REZONING: CONDITIONAL REZONING - DUNCAN TERRACE (P21-79-CZD)
CITY OF HENDERSONVILLE - COMMUNITY DEVELOPMENT STAFF REPORT

PROJECT SUMMARY

Site Plan Comments

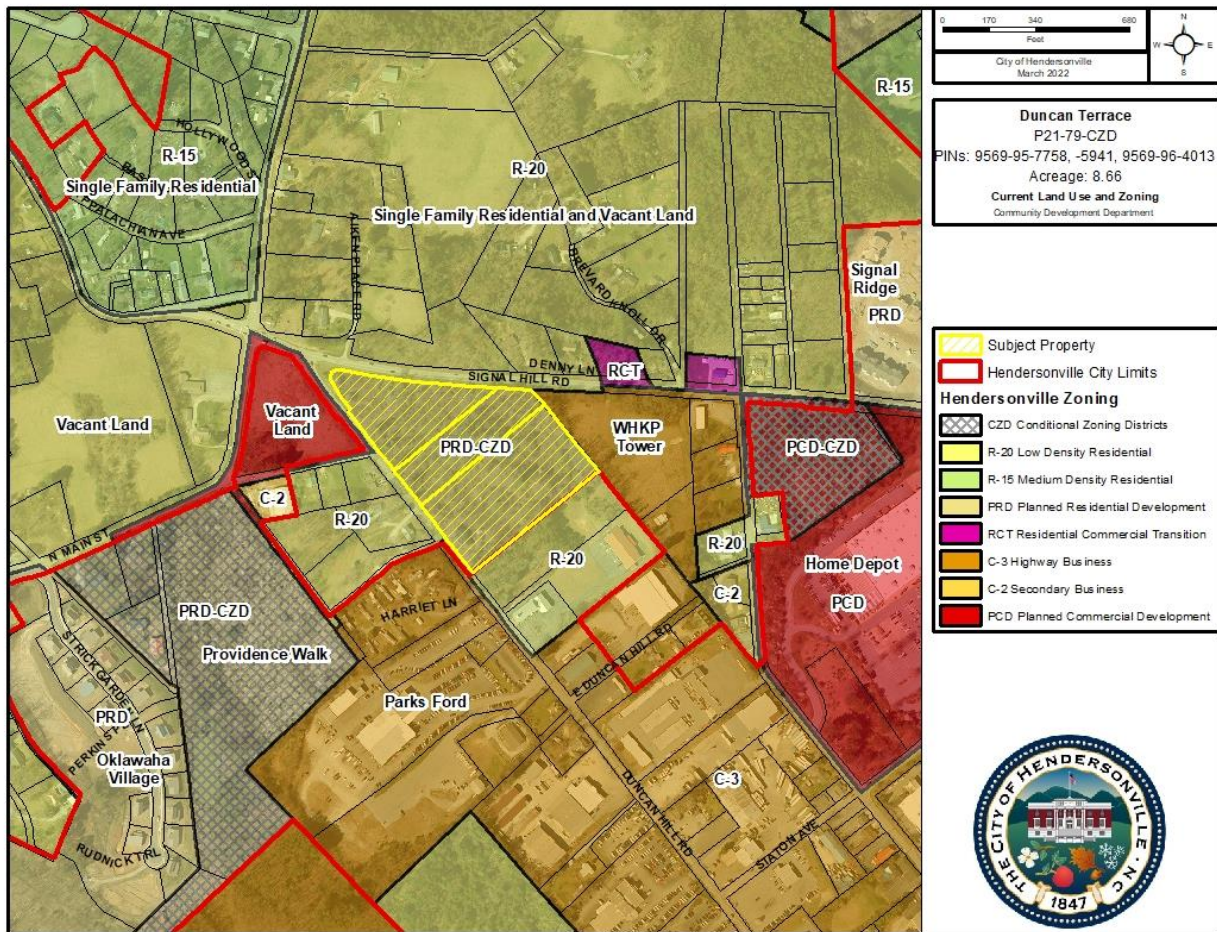
- The site plan accompanying this petition meets the standards established by the Zoning Ordinance for Planned Residential Development (5-14) and Site Plan Review (7-3) with the following exceptions:
 - Parking spaces are 9’x20’ – exceeding the minimum site requirements
 - Some plants on the proposed landscaping plan are not on the City’s recommended species list.
 - The height is not measured correctly to the mean point of the gabled roof

from the average elevation at the base of the structures.

- Final site plans will require location of FDC's and hydrants.

- Increase island size for the right in, right out to deter people from turning left [Address at Final Site Plan].
- Will need a sidewalk encroachment from NCDOT

- Allow a right in, right out access onto Signal Hill Road even though Signal Hill Road is not designated as a boulevard or throughfare as required in section 5-14-5 (b) Density Bonus. [Developer Agreed]
- Allow the developer to construct sidewalks along Baldwin Hill Avenue to tie into Providence Walk's future sidewalk network instead of constructing sidewalks between the driveway accesses on Duncan Hill and Signal Hill Roads due to the

probability of those sidewalks being removed when NCDOT makes improvements to Duncan Hill and Signal Hill Roads. [Developer Agreed]
